# FINAL DRAFT MINUTES

## July 15, 2021 Standards Committee Meeting

RE: Minutes from the July 15, 2021 Standards Committee Meeting

STANDARD SPECIFICATIONS, SPECIAL PROVISIONS AND STANDARD DRAWINGS  
REVISION TO STANDARD SPECIFICATIONS, RECURRING PLAN DETAILS (RPD), AND STANDARD DRAWINGS

STANDARD DRAWING NO. E 802-SBTS-09 11

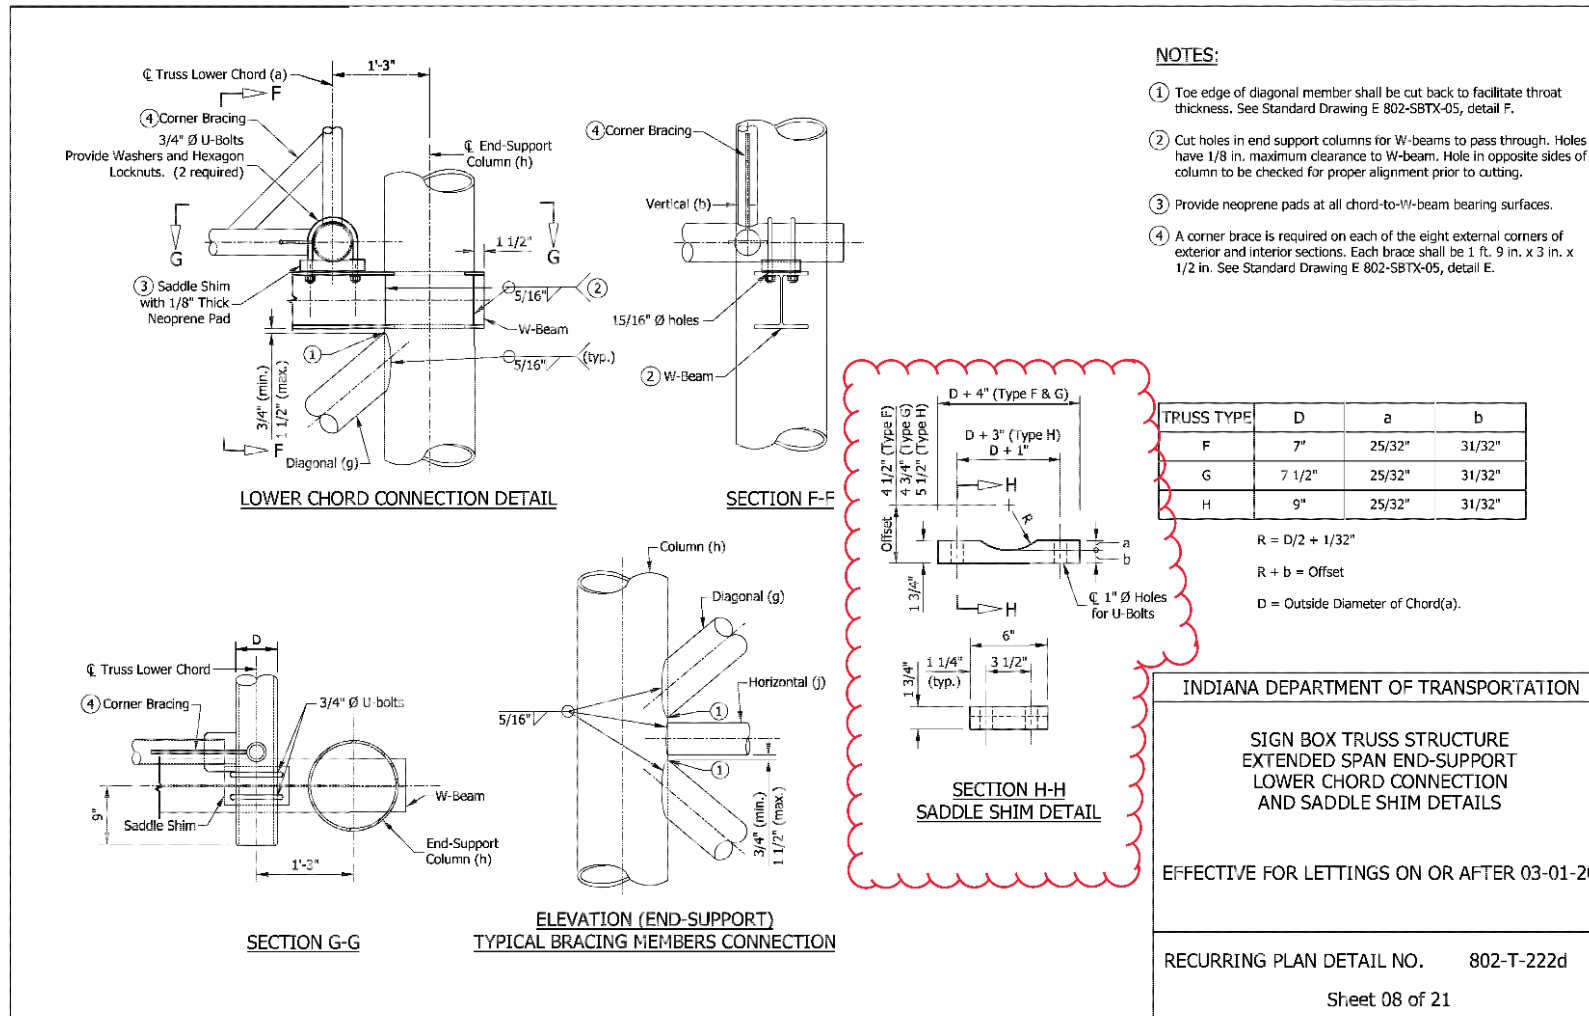
ADDING SECTION HH SADDLE SHIM DETAIL (TYPES F-H) FROM RPD 08 OF 21

**STANDARD DRAWING NO. E 802-SBTS-10 1 2**

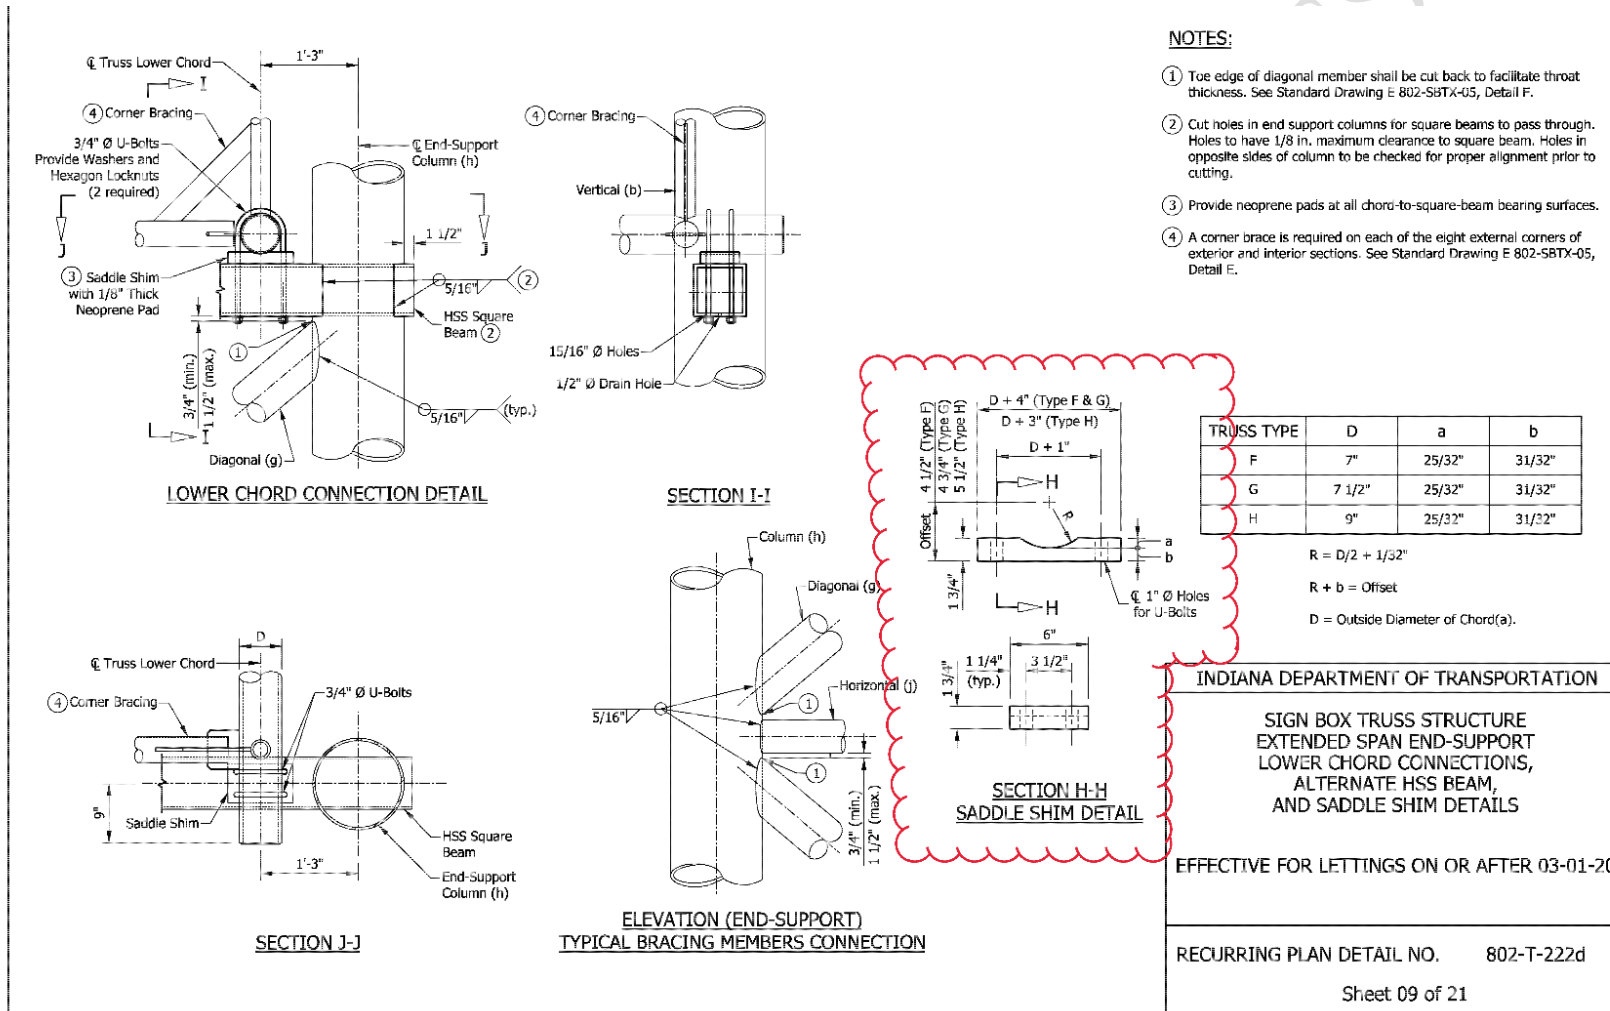
ADDING SECTION HH SADDLE SHIM DETAIL (TYPES F-H) FROM RPD 09 OF 21

REVISION TO STANDARD SPECIFICATIONS, RECURRING PLAN DETAILS (RPD), AND STANDARD DRAWINGS  
 E 802-SBTS series, RPD 802-T-222d (WITH MARKUPS)

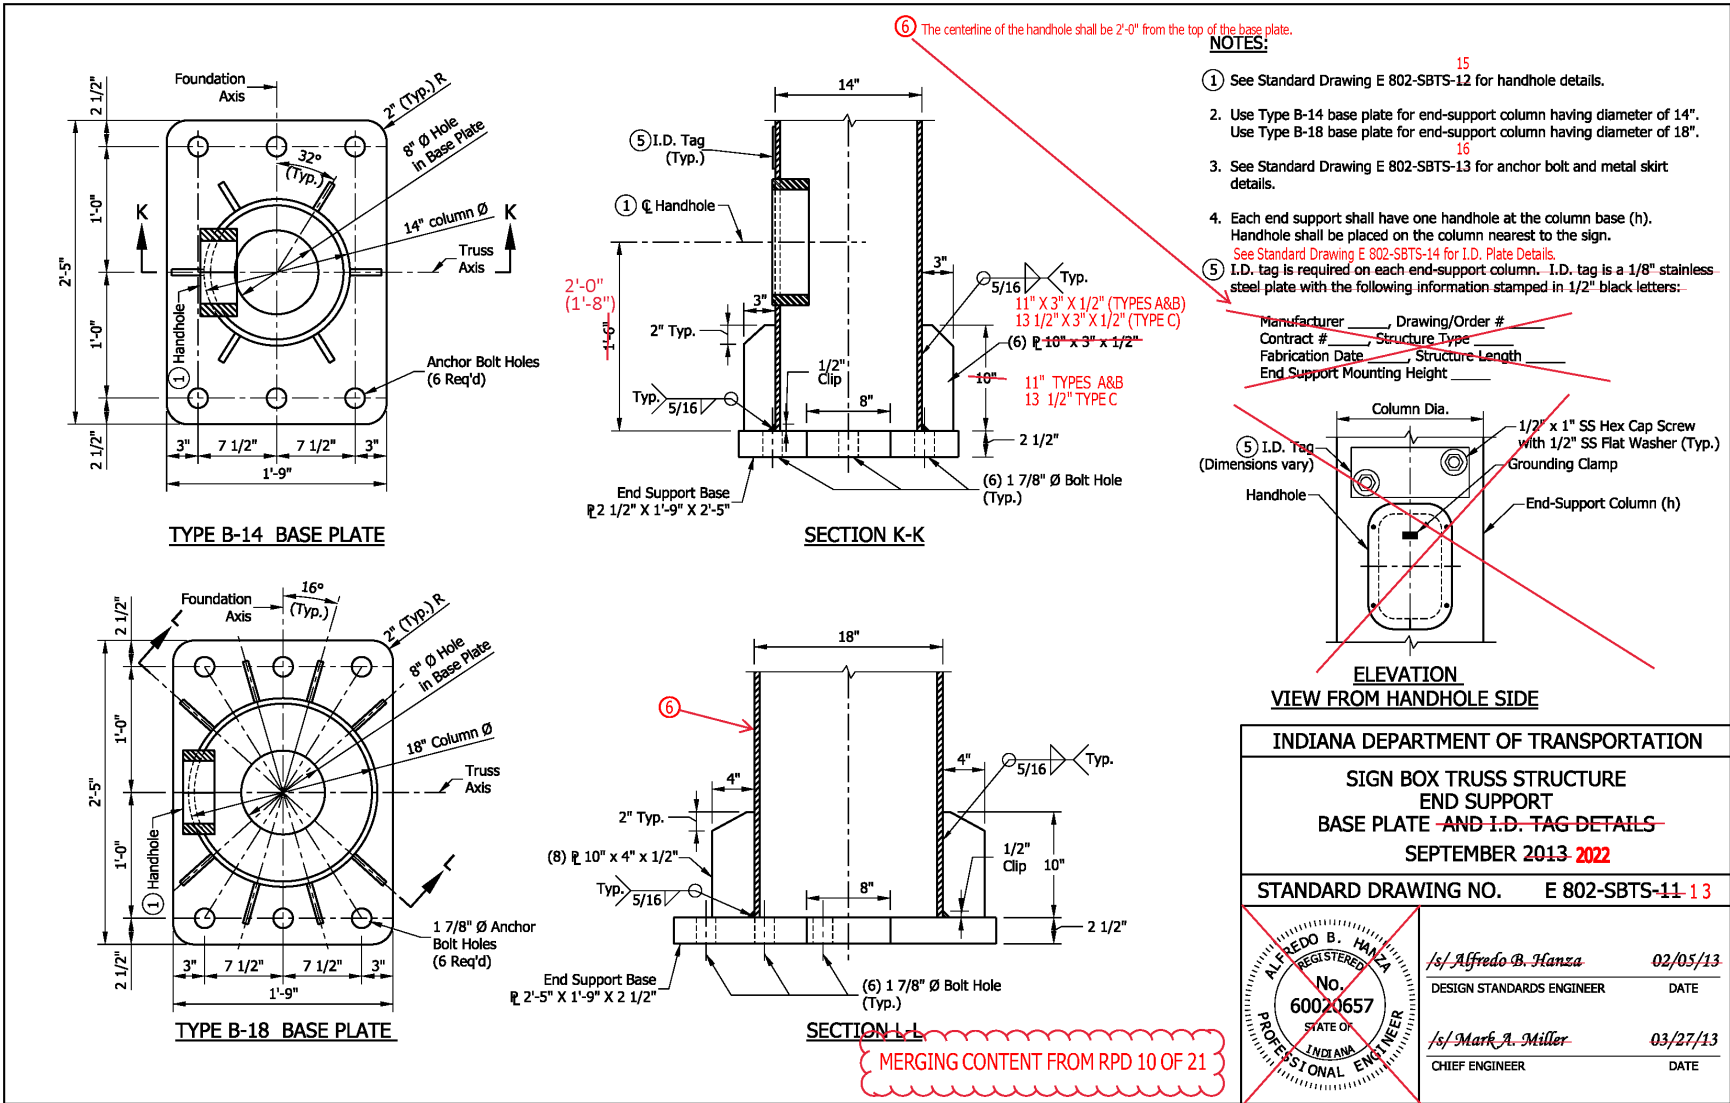
**MERGING RPD WITH 802-SBTS-12**

INDIANA DEPARTMENT OF TRANSPORTATION	
SIGN BOX TRUSS STRUCTURE EXTENDED SPAN END-SUPPORT ANCHOR BOLT AND METAL SKIRT DETAILS	
EFFECTIVE FOR LETTINGS ON OR AFTER 03-01-20	
RECURRING PLAN DETAIL NO.	802-T-222d
Sheet 13 of 21

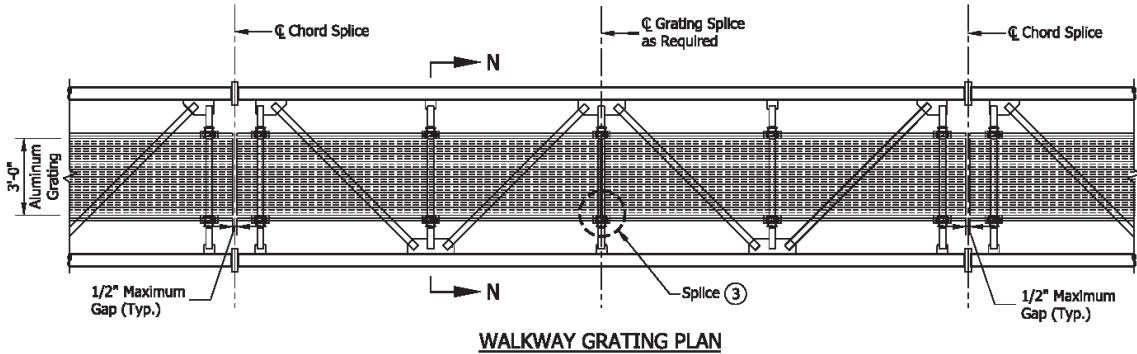
MERGING CONTENT WITH 802-SBTS-16

REVISION TO STANDARD SPECIFICATIONS, RECURRING PLAN DETAILS (RPD), AND STANDARD DRAWINGS  
 E 802-SBTS series, RPD 802-T-222d (WITH MARKUPS)

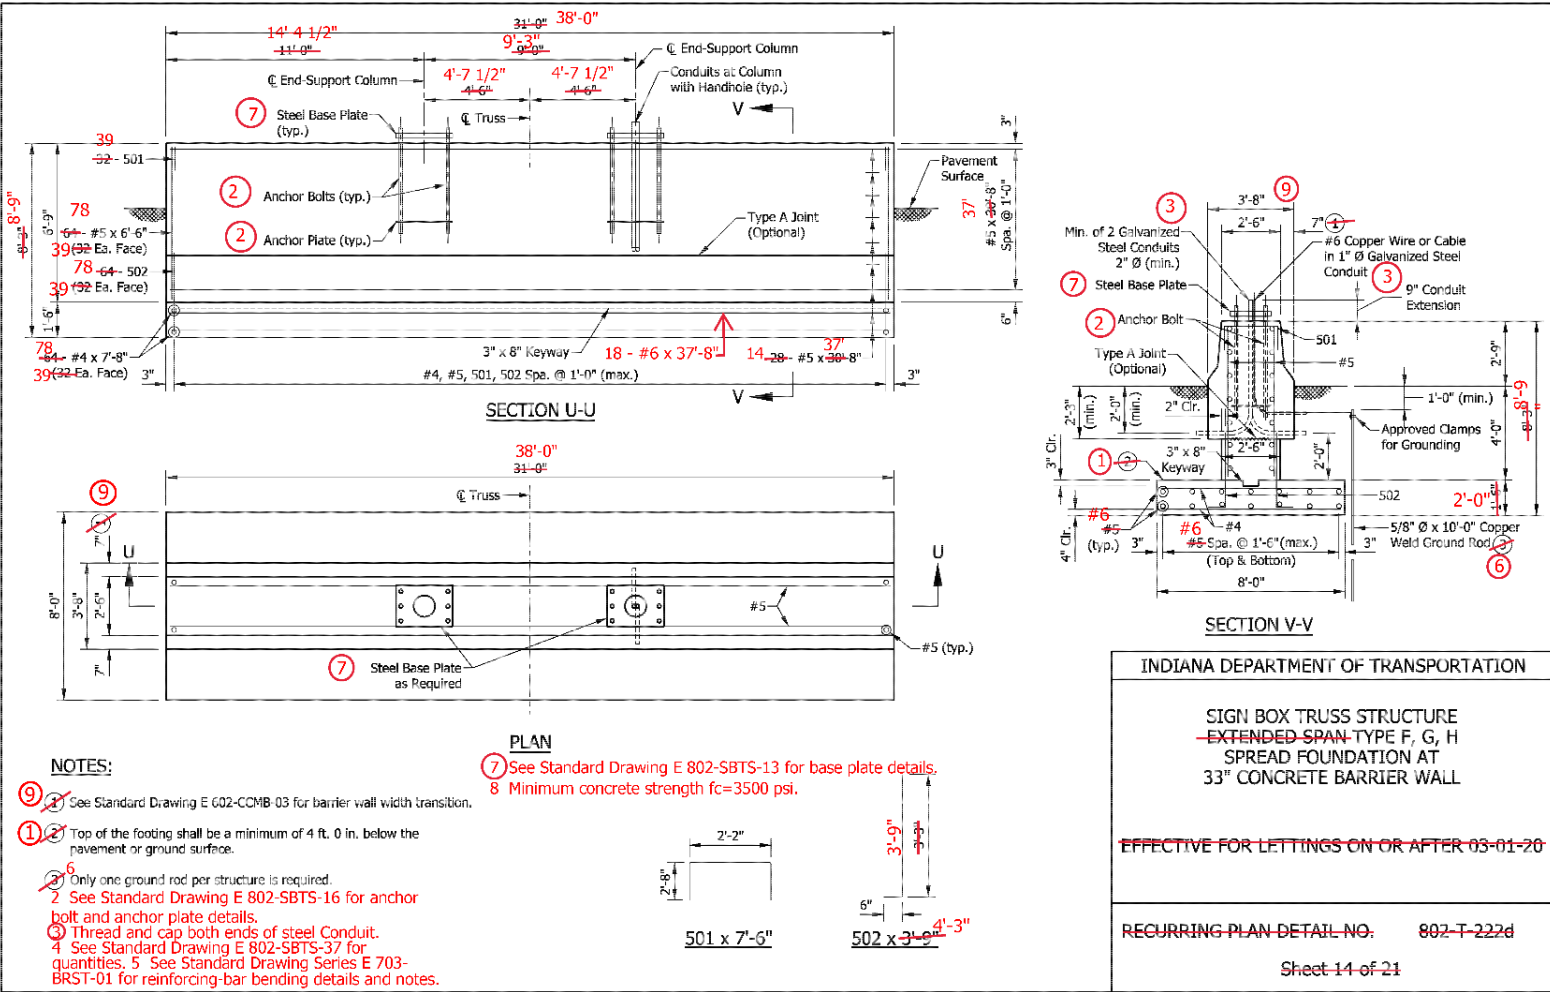
RPD 14 OF 21 BECOMES 802 SBTS-34

REVISION TO STANDARD SPECIFICATIONS, RECURRING PLAN DETAILS (RPD), AND STANDARD DRAWINGS  
 E 802-SBTS series, RPD 802-T-222d (WITH MARKUPS)

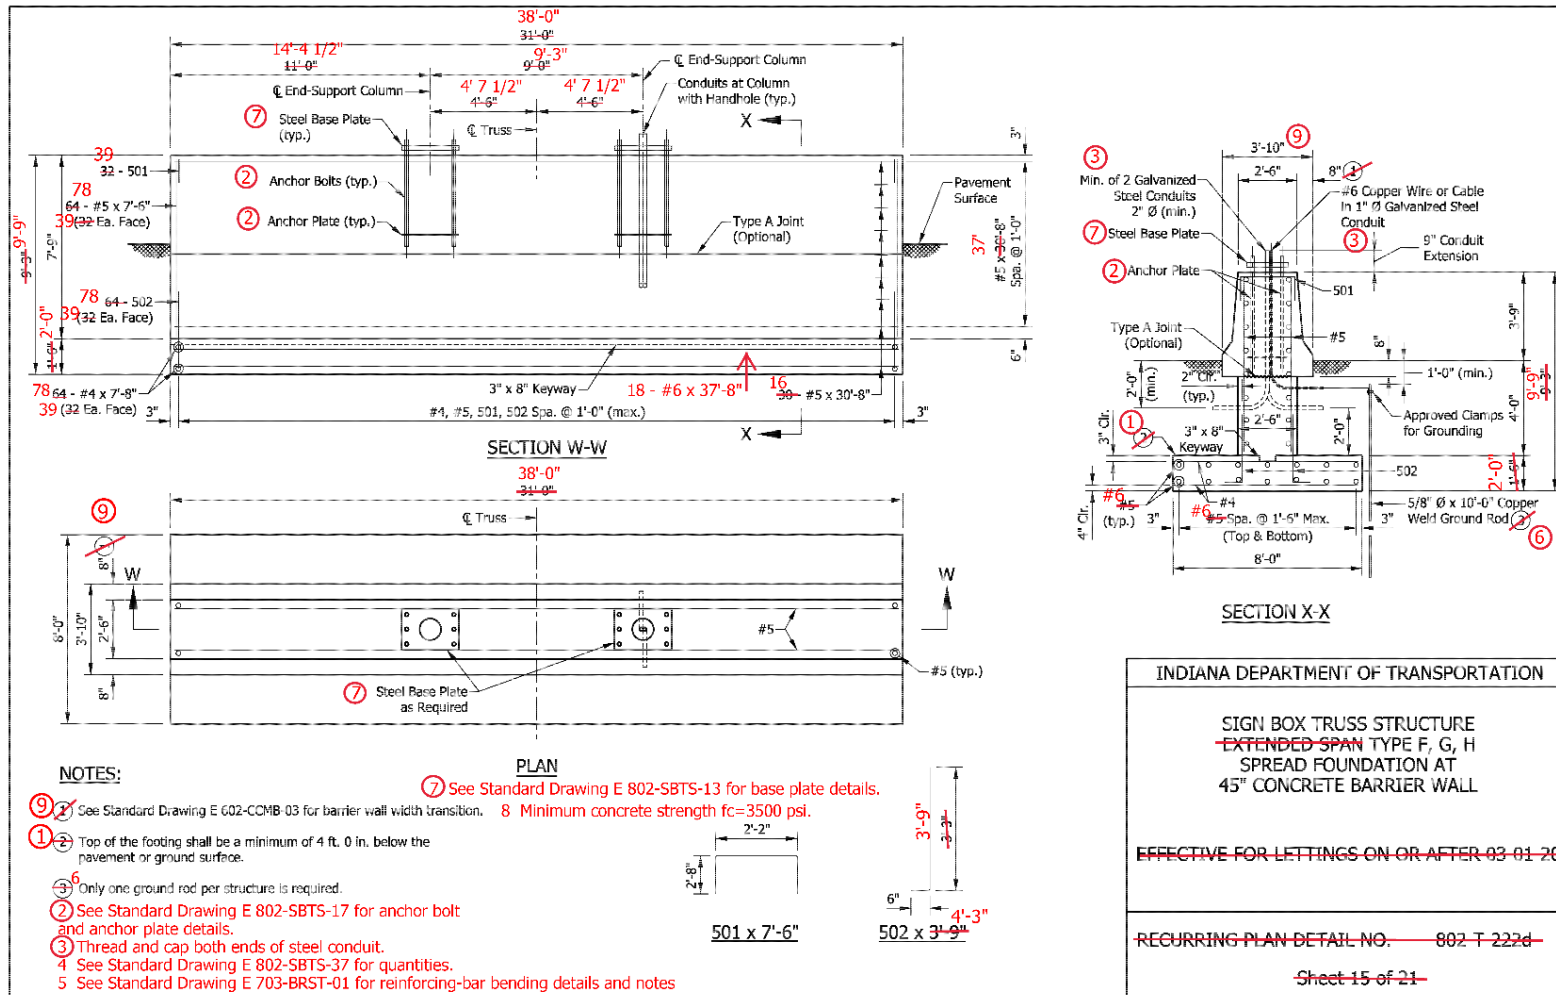
RPD 15 OF 21 BECOMES 802 SBTS-35

E 802-SBTS series (PROPOSED DRAFT -01 thru -41) Sheet 13 (revised draft)

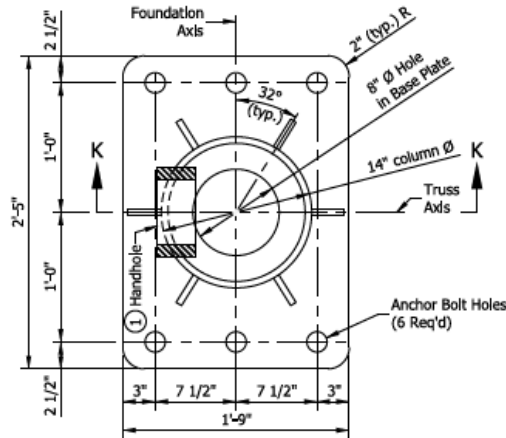
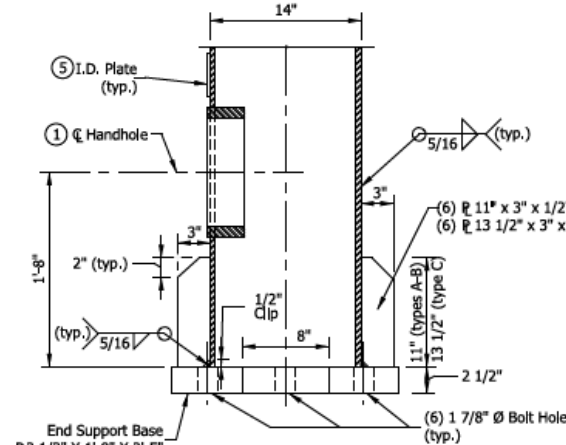
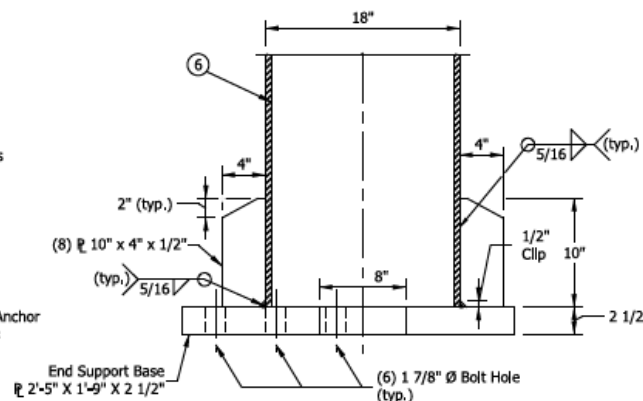
Also, additional detail on sheet 13 (revised draft shown in these minutes) is to provide for the crossing of the diagonal members in the end supports; the other changes are in formatting or are editorial per the Standards Office.
